ADDENDUM NO. 1

**Water & Wastewater Improvements
Graham Cave State Park
Danville, Missouri
Project No. X2321-01**

Bidders are hereby informed that the construction Plans and/or Specifications are modified as follows:

C-204

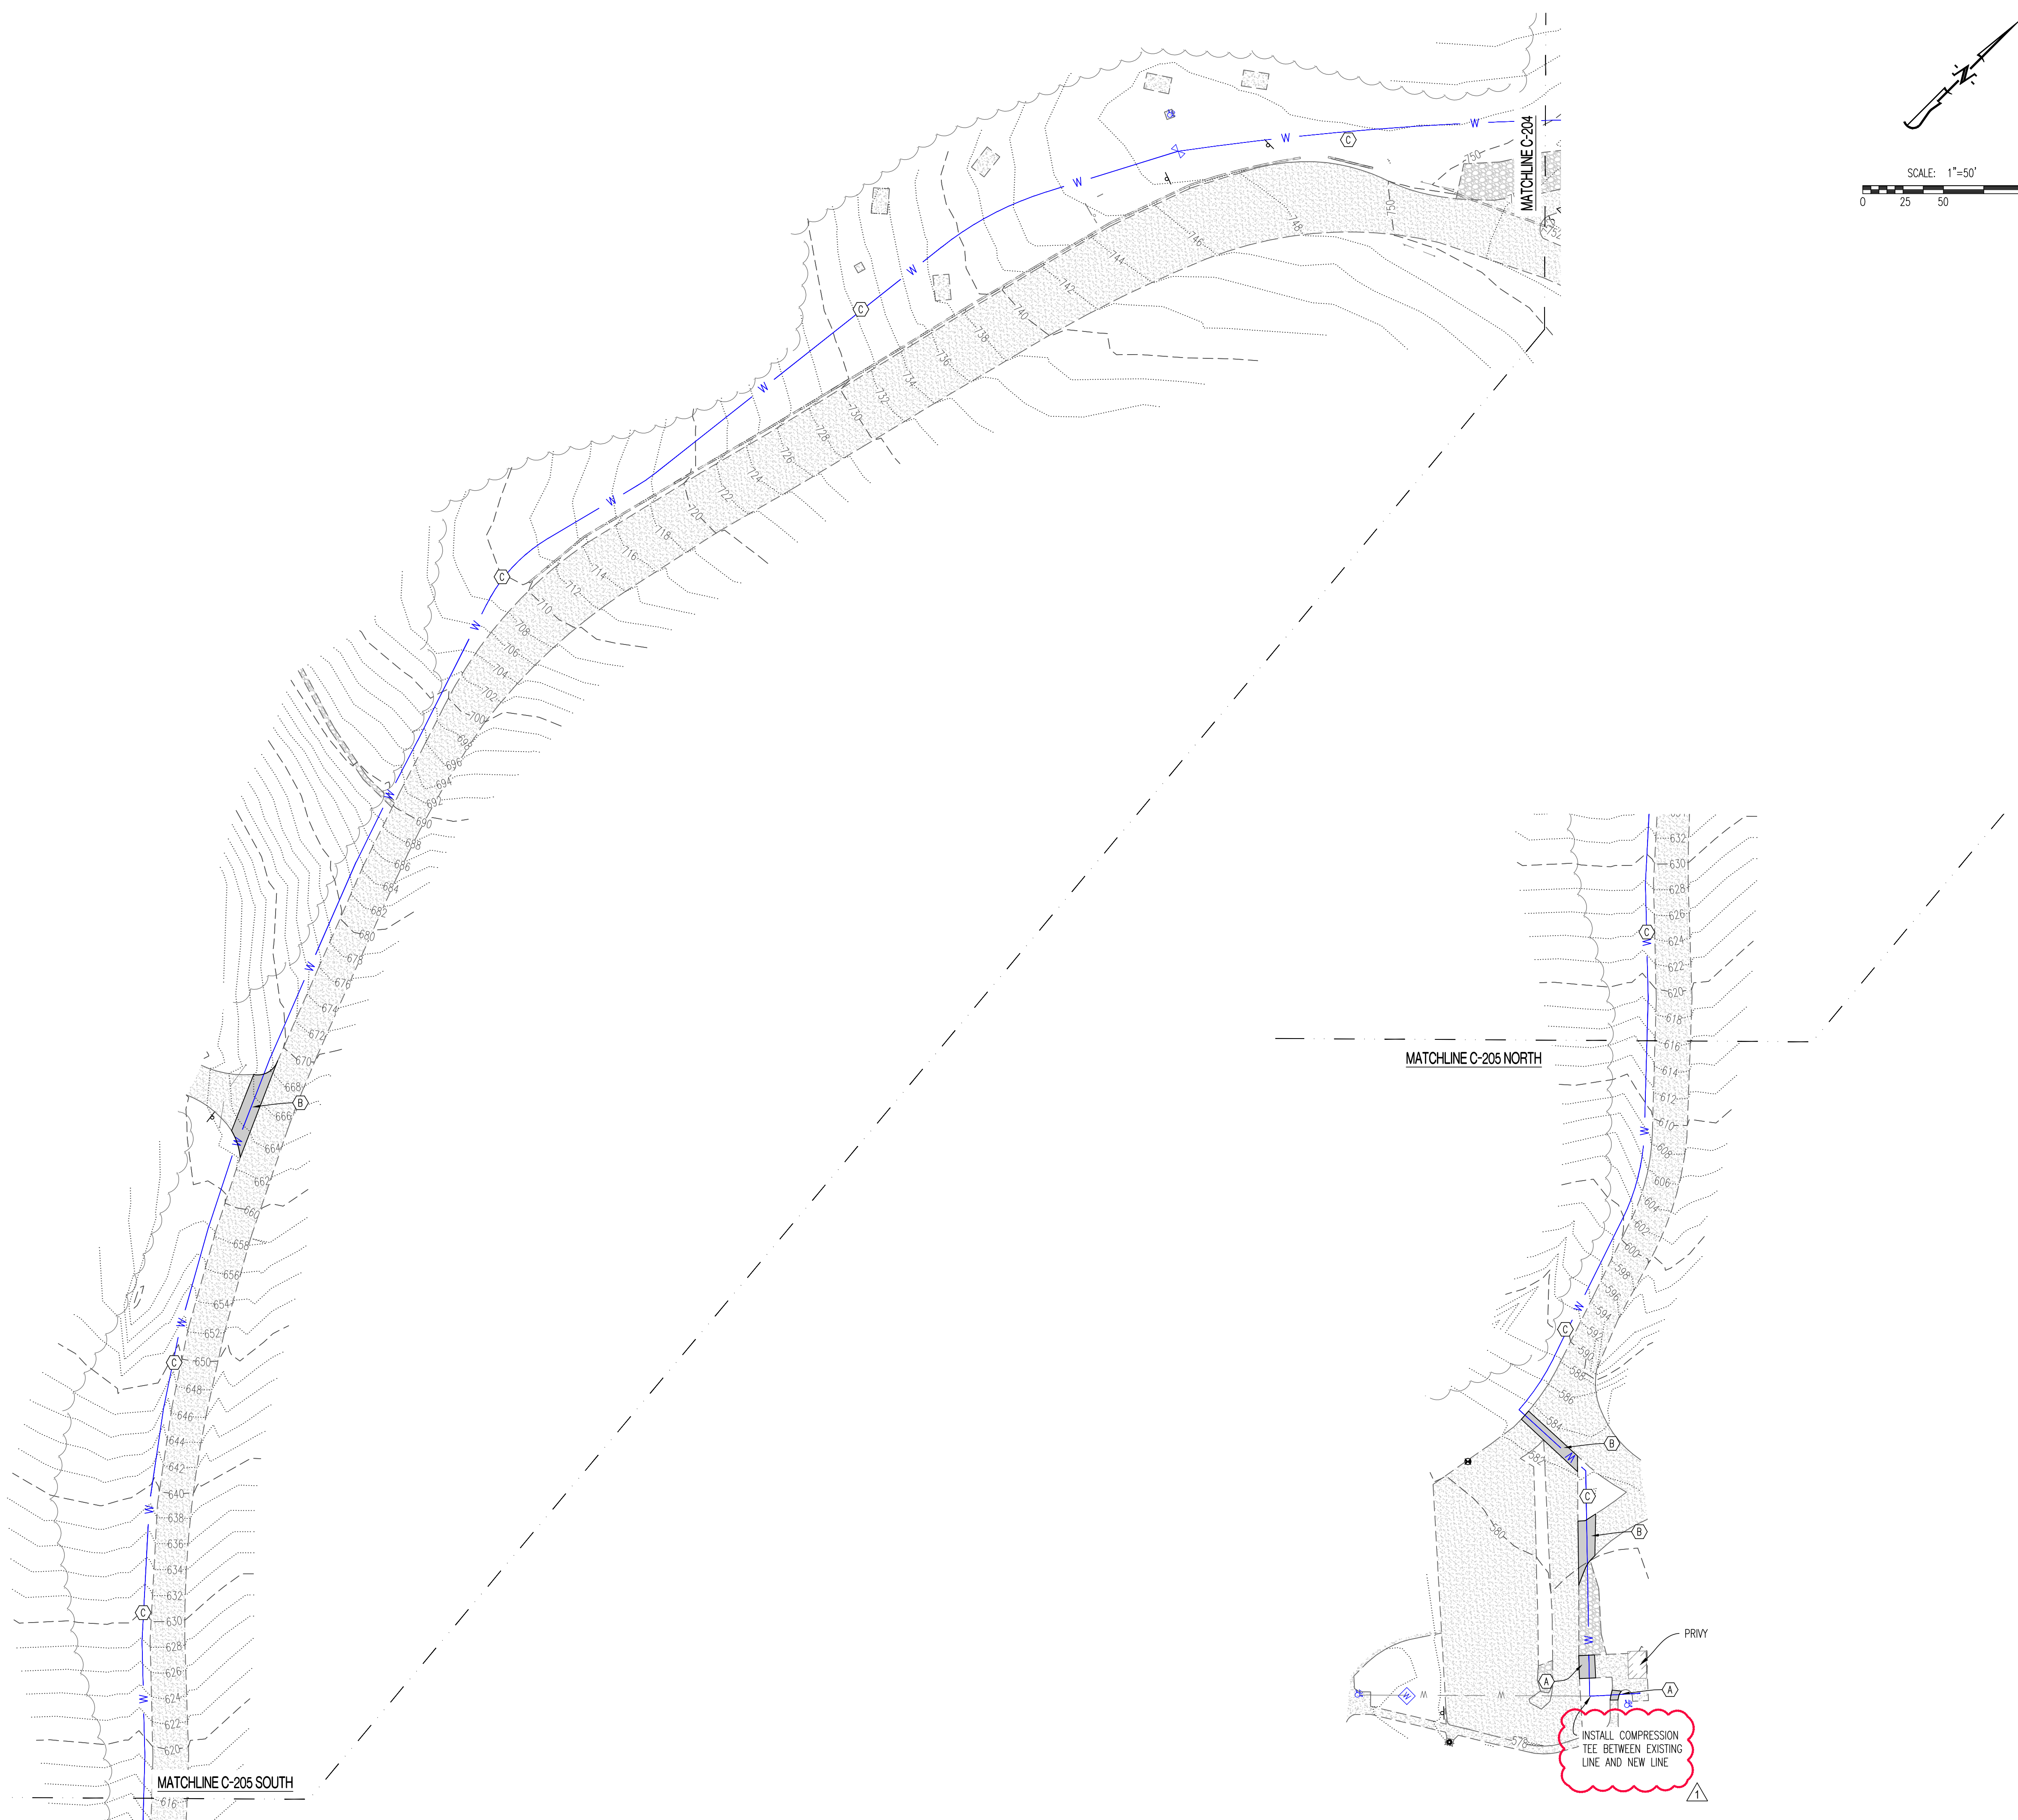
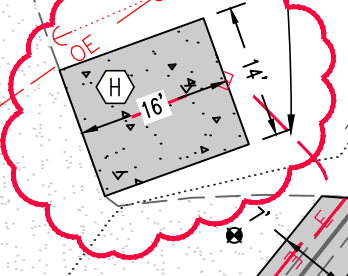
7. Sheet C-204
 - a. Fuel tank pad dimensions adjusted.
 - b. Conduit path from well house to fuel tanks shown.
 - c. Key note C amended to clarify rock removal and frost requirements.

- d. Key note F modified to allow for concrete patching in lieu of asphalt patch option.
 - e. Key note I added to show requirements for new PVC sewer piping installation.

- f. Key note J added to show bollard protection required at well head. Plan view amended to show three bollards to protect well head.
 - g. See attached revised drawing.

- (C) INSTALL 1.5" POLY WATERLINE FROM WELLHOUSE TO EXISTING EXTERIOR WATER LOOP. RECONNECT WATERLINE AT OFFICE AND RANGER HOUSE. SEE INSTALLATION DETAILS ON C-302. CONTRACTOR IS CAUTIONED THAT ROCK REMOVAL IS UNCLASSIFIED AND PORTIONS OF THE TRENCH MAY REQUIRE TRENCH ROCK EXCAVATION TO MAINTAIN FROST COVERAGE.

- (D) INSTALL ELECTRICAL WIRING FROM WELL HOUSE TO SEWER SYSTEM. SEE E-102.
 - (E) INSTALL ELECTRICAL FROM WELL HOUSE TO EXISTING POLE. SEE E-102
 - (F) PATCH EXISTING ASPHALT. SEE DETAIL ON C-302. NOTE THAT CONCRETE PATCH OPTION IS ACCEPTABLE IN ASPHALT AREAS PER THE DETAIL.

- (J) INSTALL 3 BOLLARDS PER DETAIL ON C-302 AROUND WELLHEAD LOCATION TO PROTECT WELLHEAD FROM VEHICULAR TRAFFIC.

INSTALL NEW CONDUIT AND WIRING FROM WELL HOUSE TO GAS TANK LOCATION.

C-205

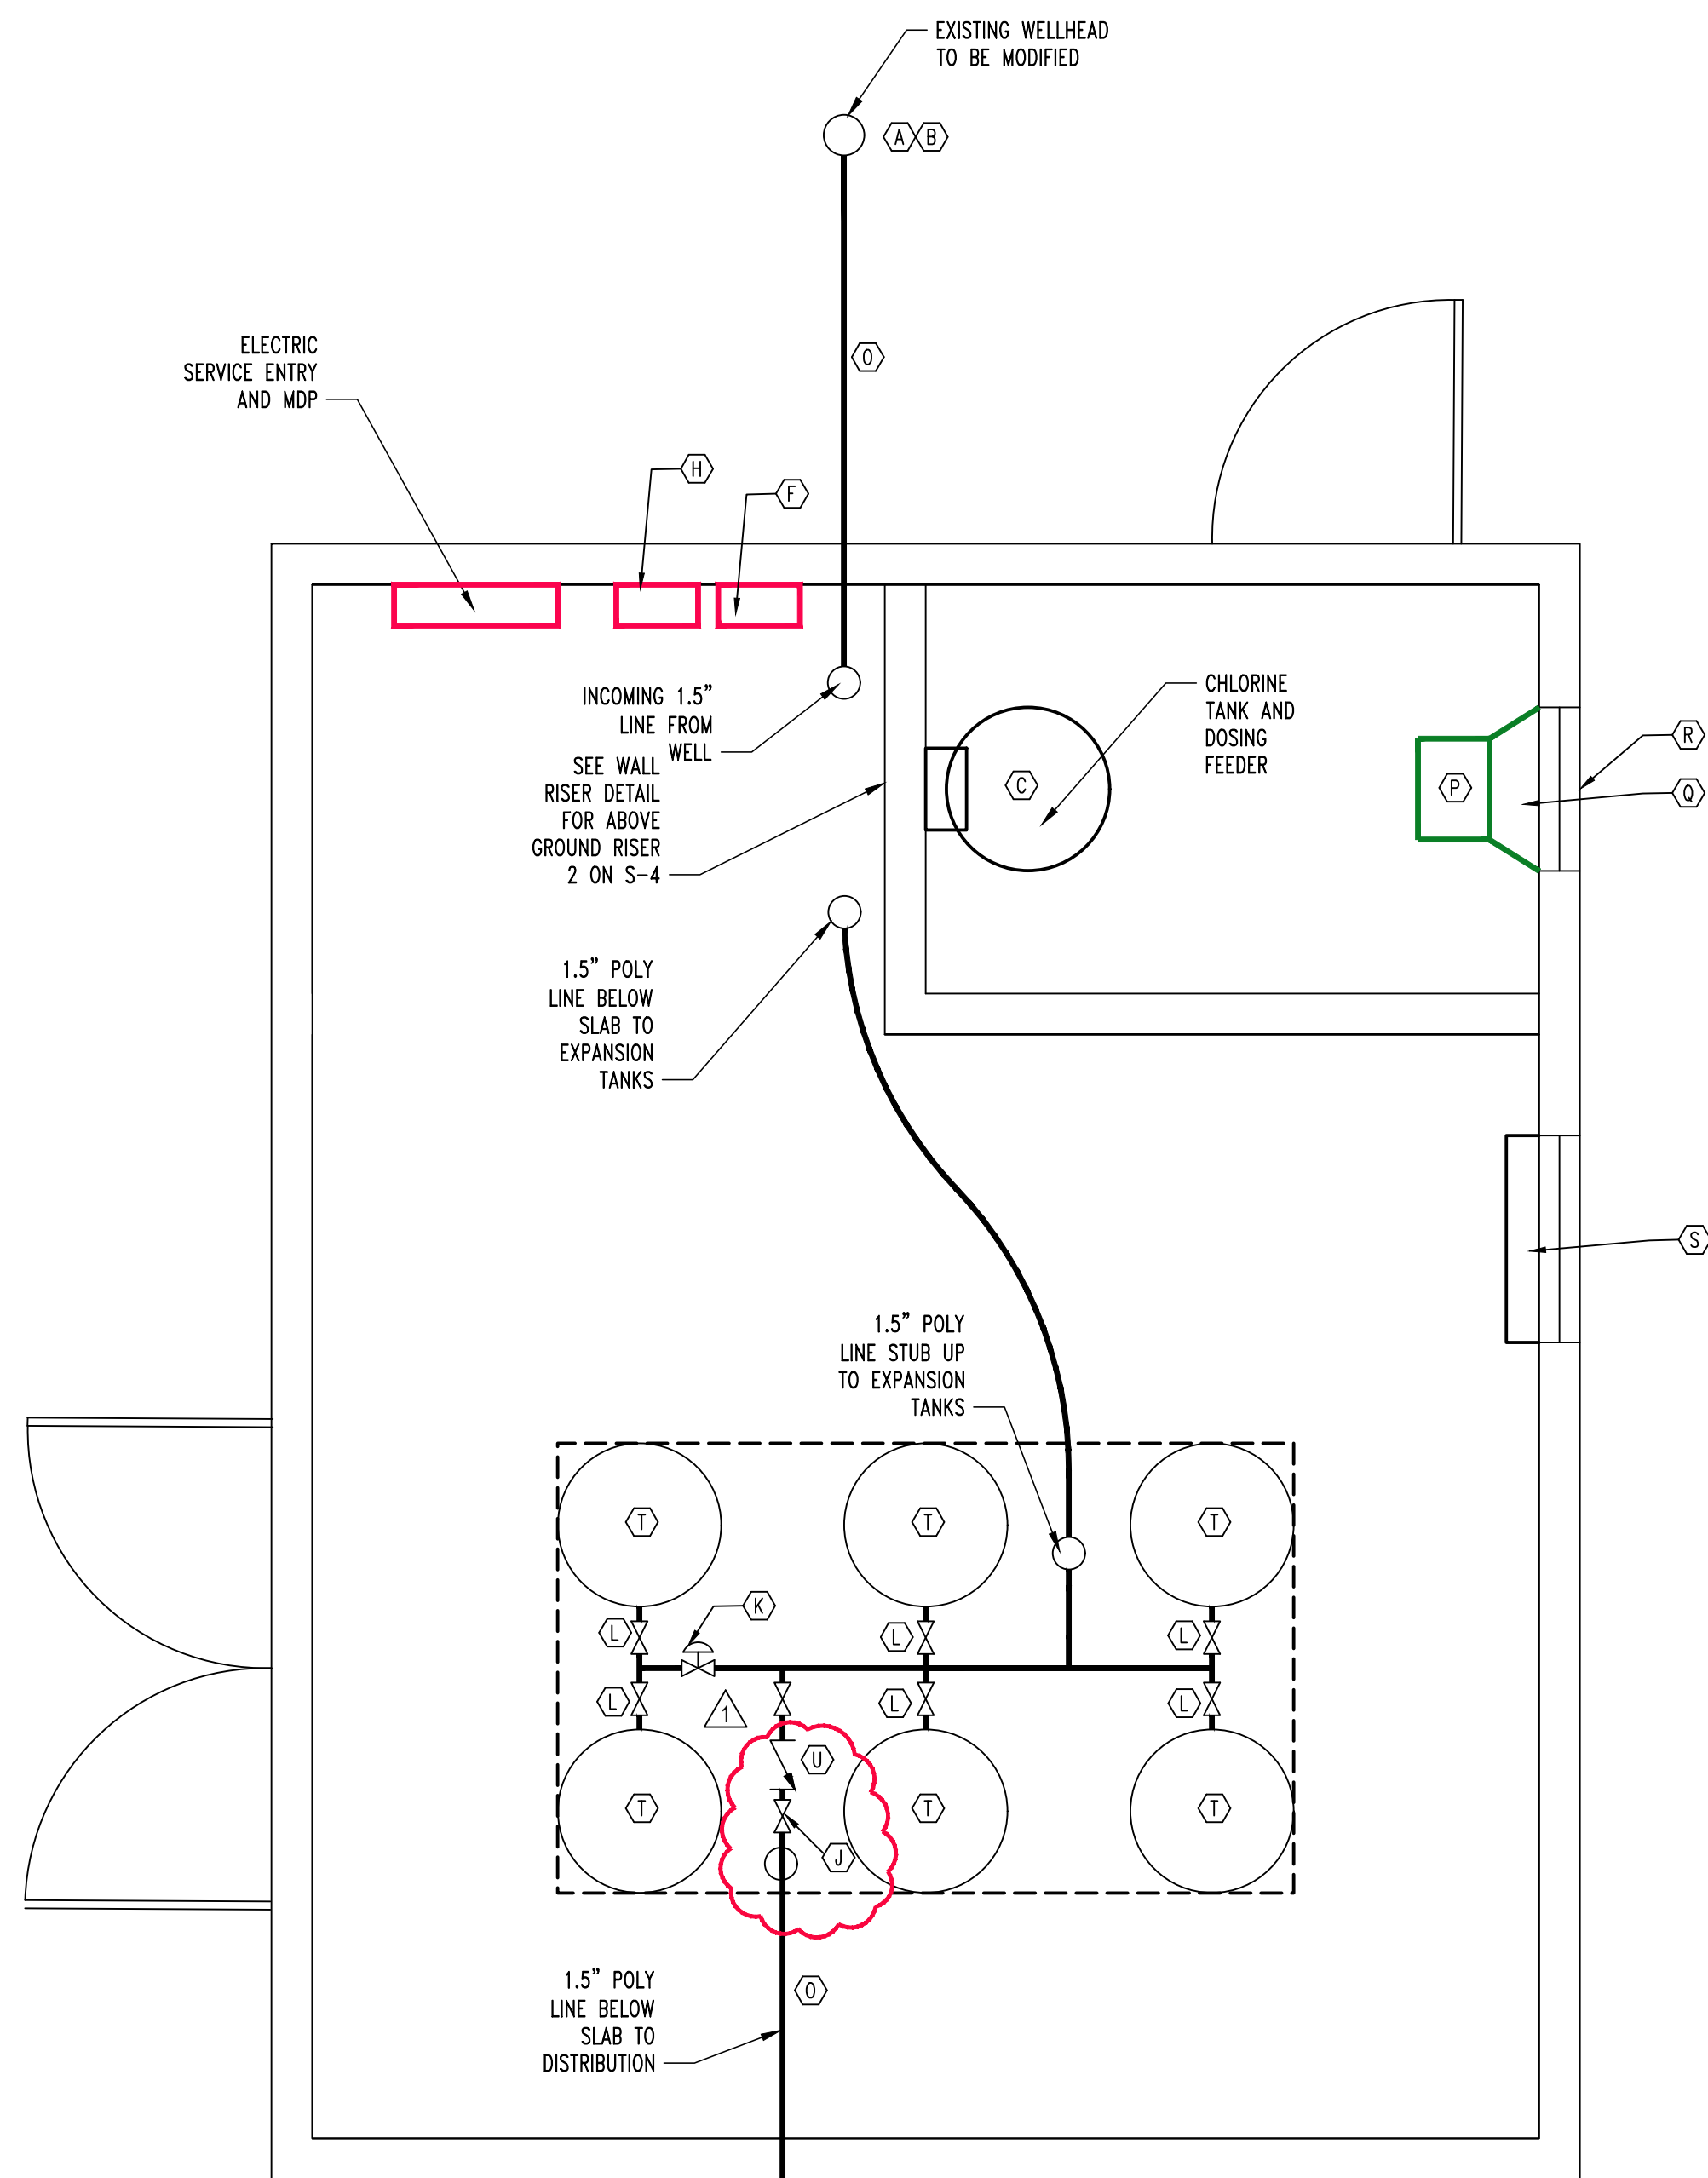
8. Sheet C-205
 - a. Key note C amended to show rock chipping requirements and trench excavation requirements.
 - b. Arrow note added showing connection between old and new piping at Pavilion area.

- c. See attached revised drawing.
9. Sheet E-101
 - a. Key Note U added to show backflow device required.
 - b. Location of Key Note J valve relocated adjacent to backflow device.

WELL HOUSE
EQUIPMENT PLAN

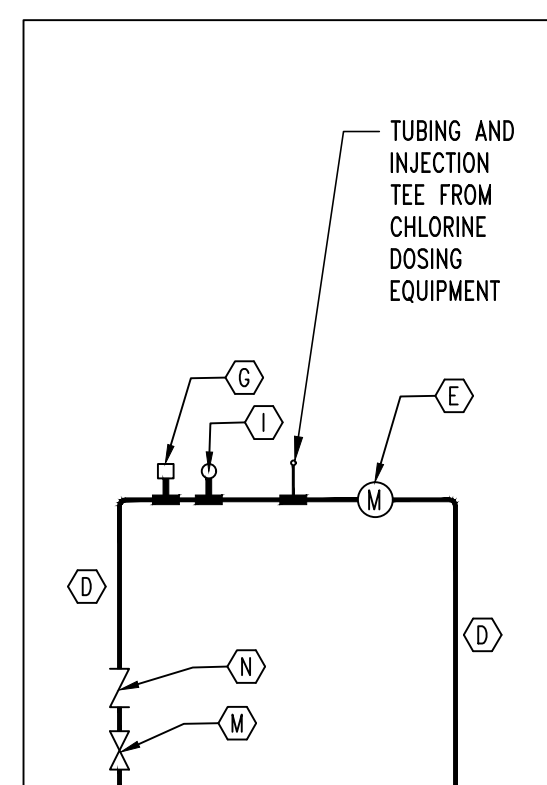
- c. Key Note D amended to show copper piping.
 - d. Well logs added for contractor reference to determine length of wiring for pumps.
 - e. See attached revised drawing.

- (D) PROVIDE 1.5" COPPER PIPING INSIDE BUILDING PRESSURE RATED AT 200 PSL. PROVIDE WALL SUPPORTS AND STANDOFFS AT A MINIMUM OF 3" ON CENTER. PROVIDE FLOOR STAND-OFFS A MINIMUM OF 3" ON CENTER.

- (U) PROVIDE DOUBLE CHECK BACKFLOW ASSEMBLY PRIOR TO BUILDING EXIT. BACKFLOW DEVICE SHALL BE EQUAL TO WATTS 007 SERIES FOR 1.5" PIPING.

NOTE: WELL LOGS PROVIDED FOR CONTRACTOR REFERENCE.
